Serial No.: 09/844,072

PROCESS AND APPARATUS

FOR ACHIEVING PRECISION TEMPERATURE CONTROL

SUBMISSION OF MARKED UP PARAGRAPHS

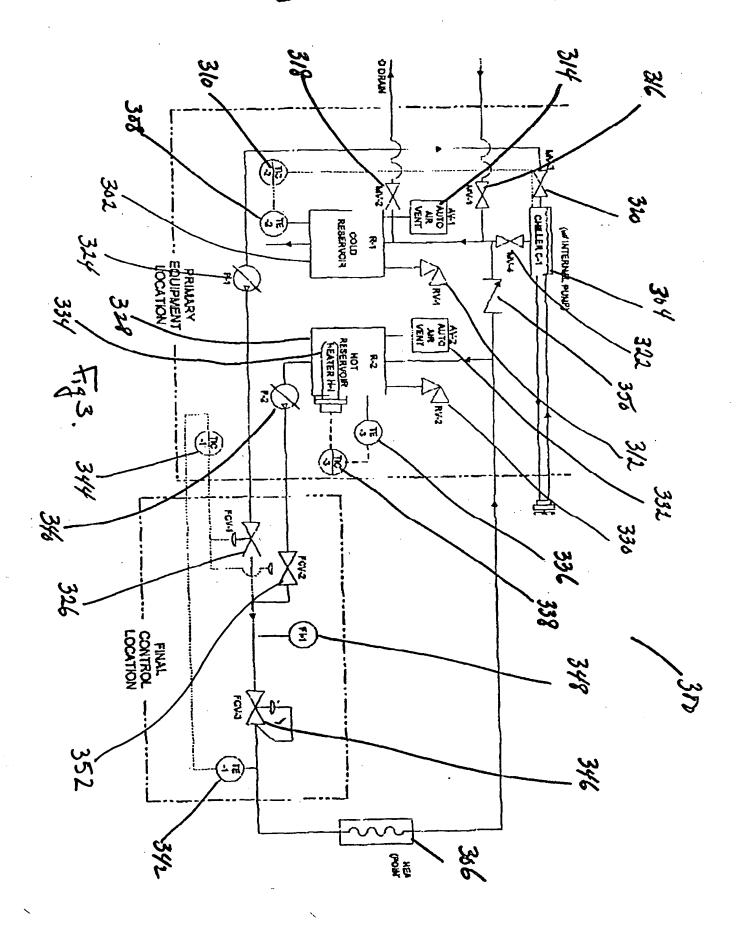
Figure 3 is a schematic illustration of a temperature control apparatus 300 for achieving precision temperature control of fluids. A temperature controller 344 compares its setpoint to the value from a sensor 342, and uses that comparison to control the position of flow control valves 326 and [346] 352, which determine the mixing ratio of hot and cold sources from reservoirs 328 and 302. Flow control valves 326 and [346] 352 positions are inversely related; as valve 326 opens, valve [346] 352 closes, and vice versa. The inverse relationship is accomplished with dual signals from controller 344, with one valve being controlled with inverse logic compared to the other.

Please remove Fig. 3 and Fig. 5 from the present application and substitute therefor the attached drawings marked Fig. 3 and Fig. 5.

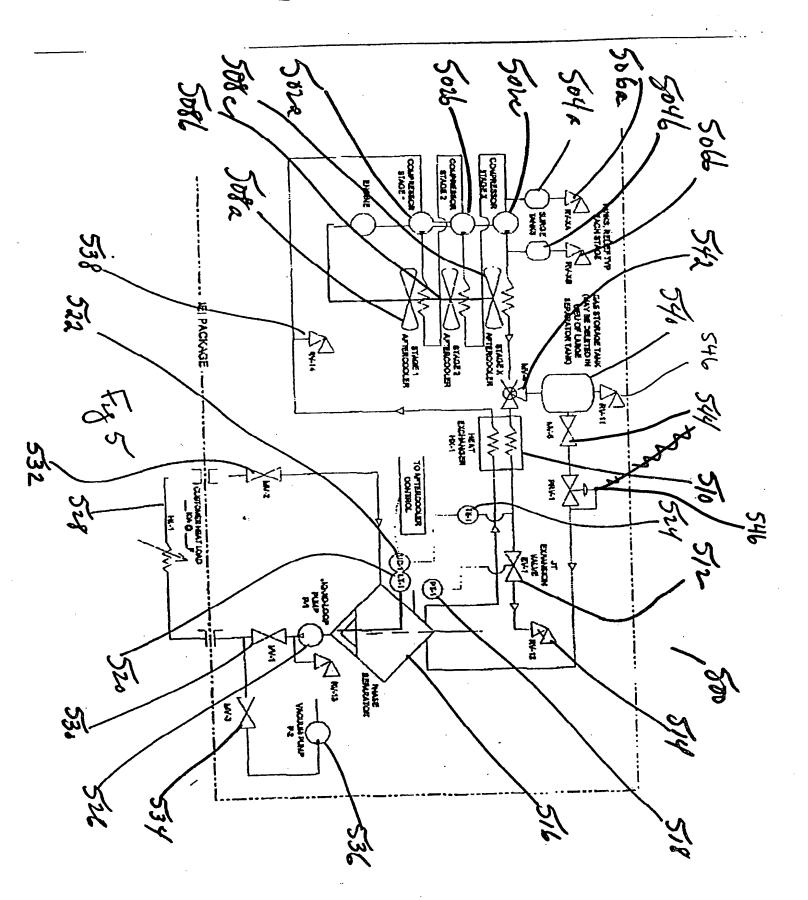
Reservoir 402_is sized to provide the appropriate amount of thermal inertia for the system. In one embodiment reservoir 402 includes a circulation pump to reduce thermal stratification within the reservoir. Manual valves 416 and 418 are normally closed, while manual valves 420 and 422 are normally open. In an alternative embodiment, these settings are reversed if facility backup cooling is used. A variable displacement pump 424 draws fluid from reservoir and delivers it to the final control location.
